SUBJECT: CRYSTAL RIVER UNIT 3 - ISSUANCE OF AMENDMENT (TAC NO. 65259)

AMENDMENT TO FACILITY OPERATING LICENSE

Amendment No. 103
License No. DPR-72

ATTACHMENT TO LICENSE AMENDMENT NO.103

Figure 3.2-2

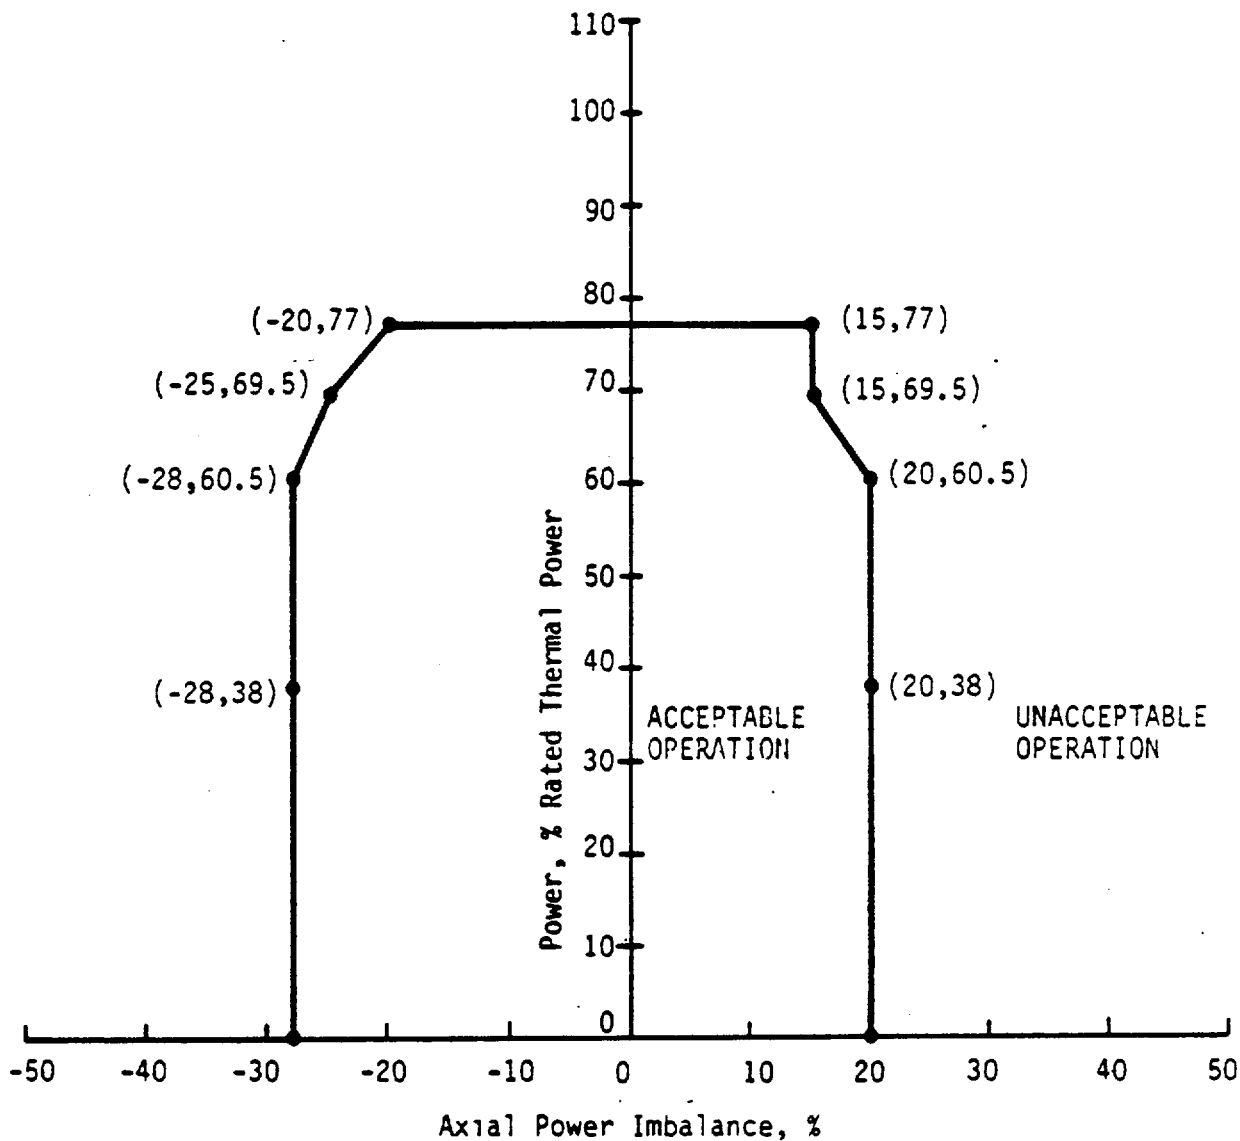
3.2.1 AXIAL POWER IMBALANCE shall be maintained within the limits shown on Figures 3.2-1, and 3.2-2.
